BY: Roberto Quiróz DATE: 8/20/2025
PROJECT #: VC25-1168

FIREFOX HOMES LLC
PLAN ALICE

12349
ANSON MILLS
EL PASO TX, 79934
BLOCK 5
LOT 12

OVERALL PLAN

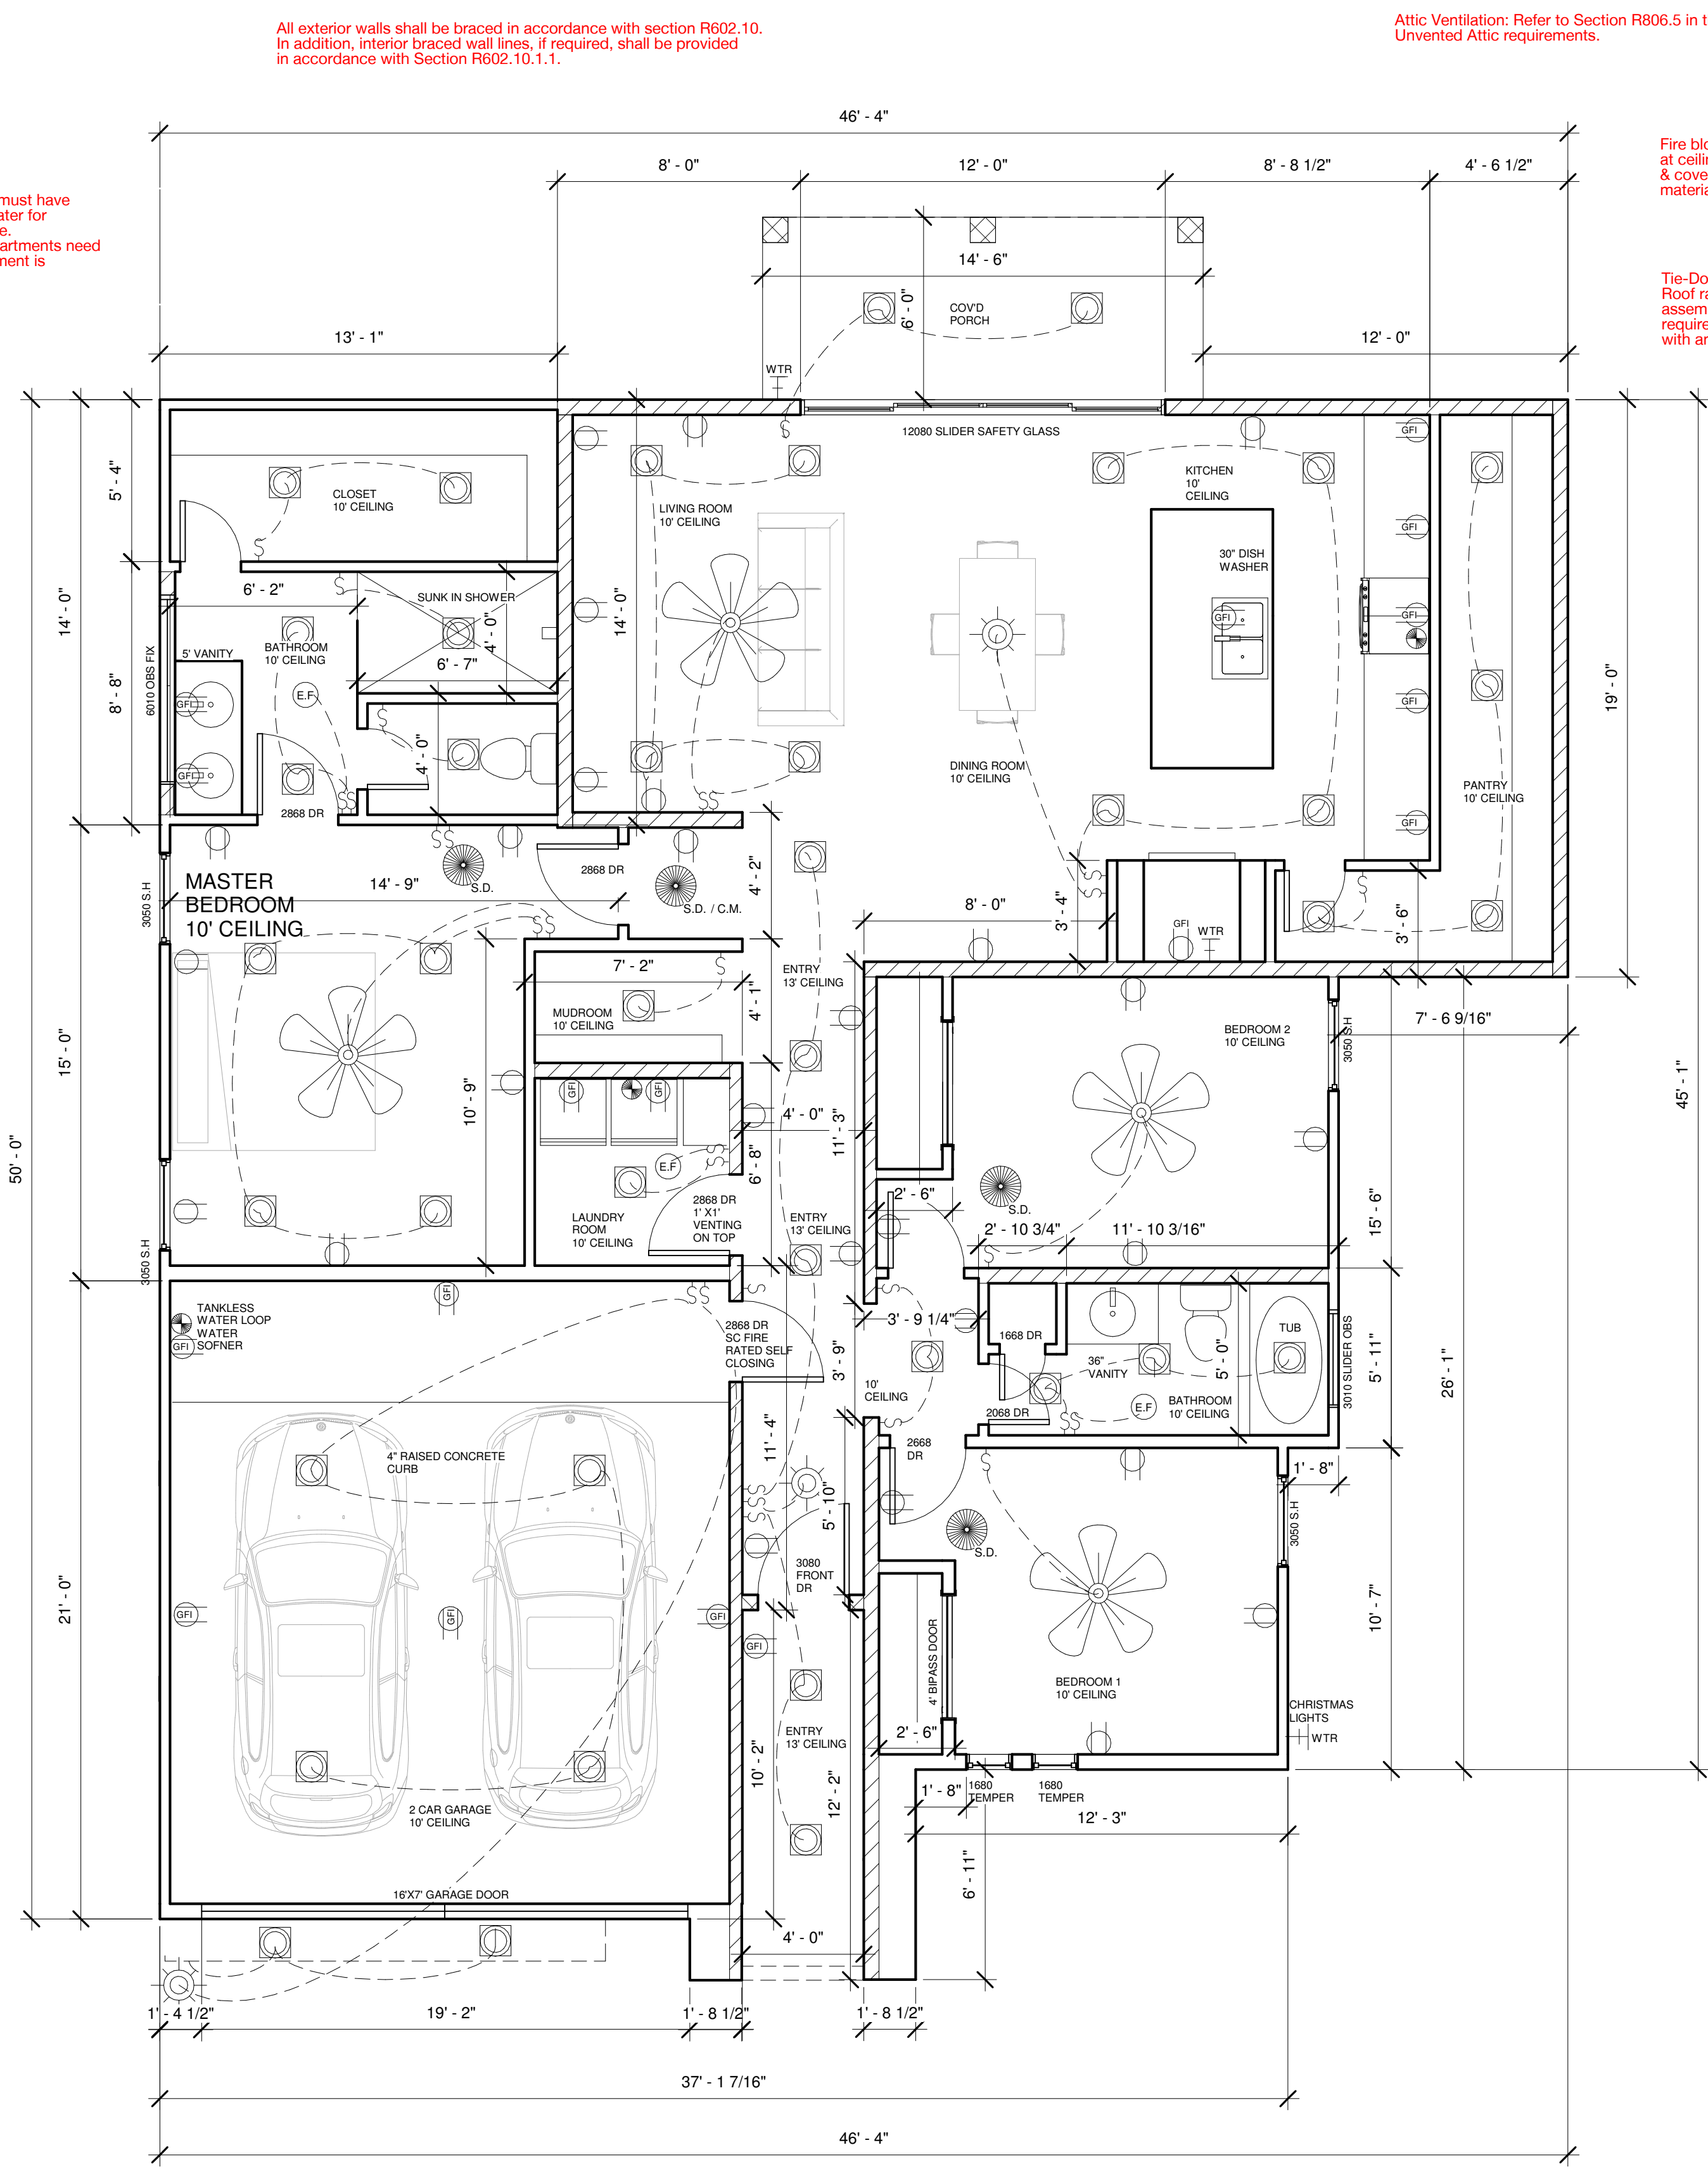
Fire blocking with approved materials must be provided in concealed spaces at ceiling and floor levels, horizontally not to exceed 10', soffits, drop & cove ceilings, between stair stringers, and the annular space around material penetrations of floors and ceilings.

SECTION CUT
PARAPET

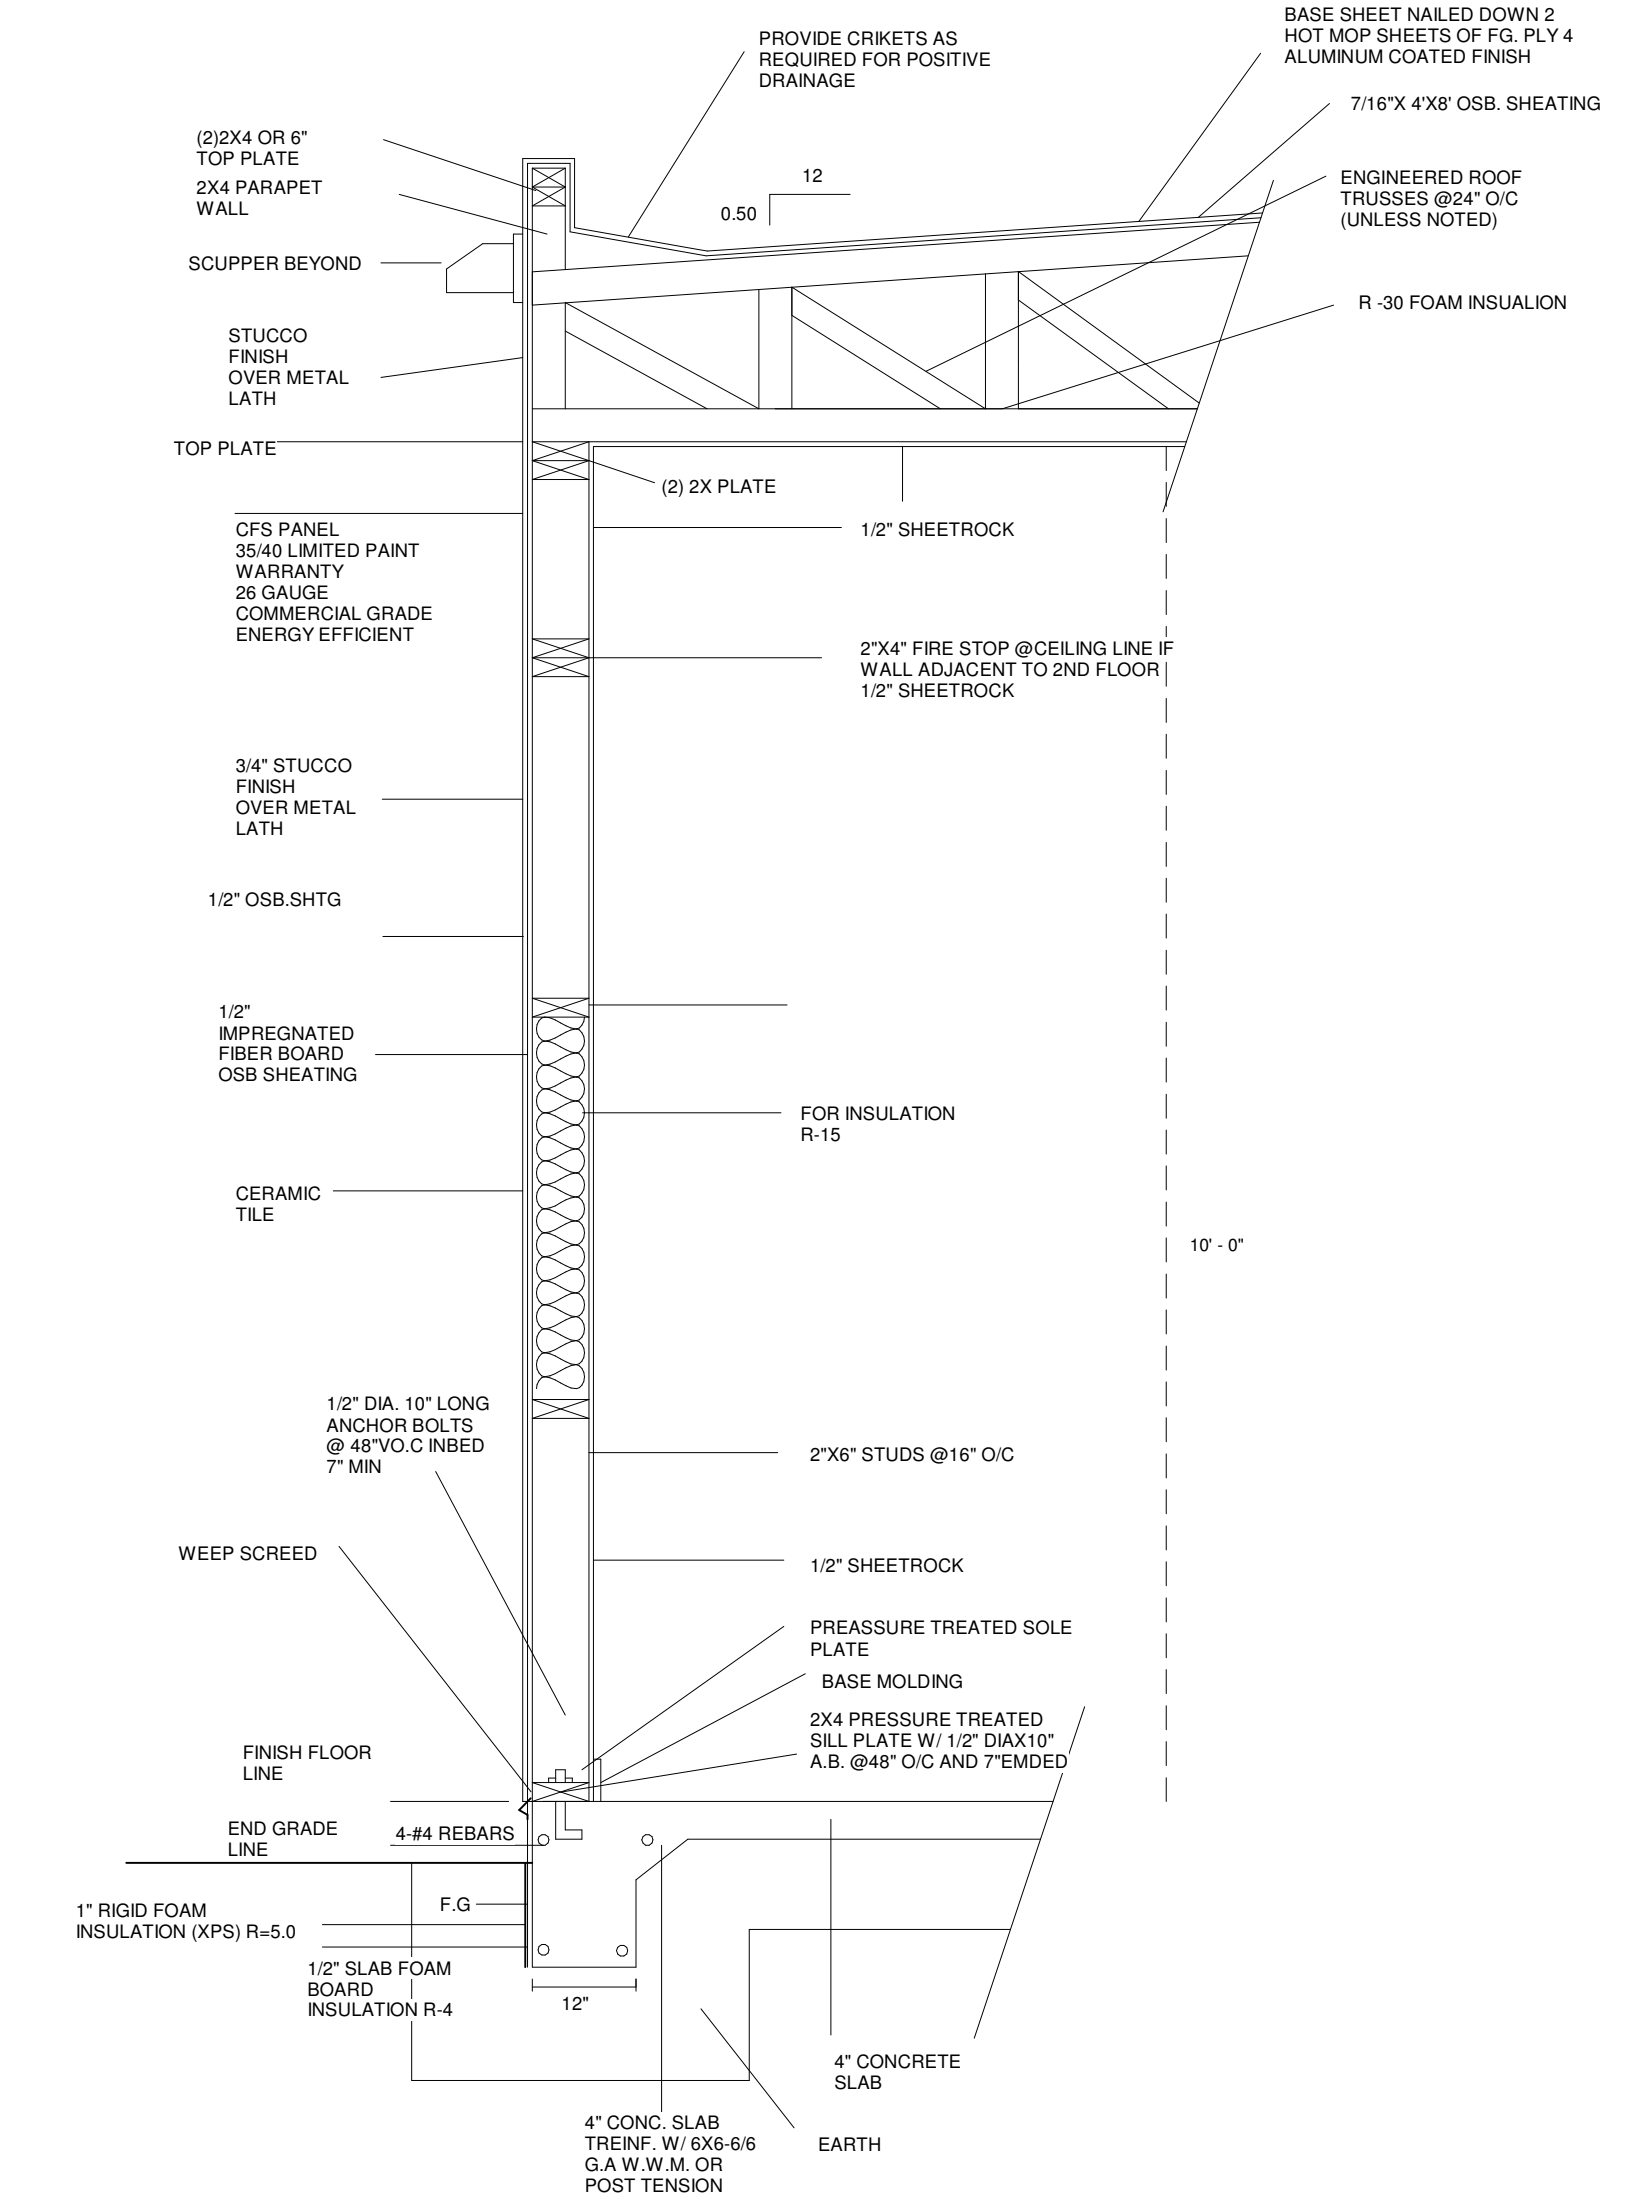
Tie-Downs:
Roof rafters and trusses must be attached to supporting wall assemblies by connections capable of providing the resistance required in Table R802.11 (from -131 to -436 pounds per connection with an overhang increase of -53.36 pounds per linear foot).

A minimum 0.019" (0.5mm) No. 26 galvanized sheet gage, corrosion-resistant weep screed or plastic weep screed, with a minimum vertical attachment flange of 3 1/2" shall be provided at or below the foundation plate line on exterior stud walls. The weep screed shall be placed a minimum of 4" above the earth or 2" above paved areas and shall be a type that will allow trapped water to drain to the exterior of the building. The weather-resistant barrier shall lap the attachment flange. The exterior lath shall cover and terminate on the attachment flange of the weep screed.

Water Resistive Barrier:
One Layer of #15 asphalt felt free from holes and breaks shall be applied over studs or sheathing of all exterior walls. Shall be applied horizontally, with the upper layer lapped over the lower layer not less than 2 inches. At joints felt shall overlap not less than 6 inches.
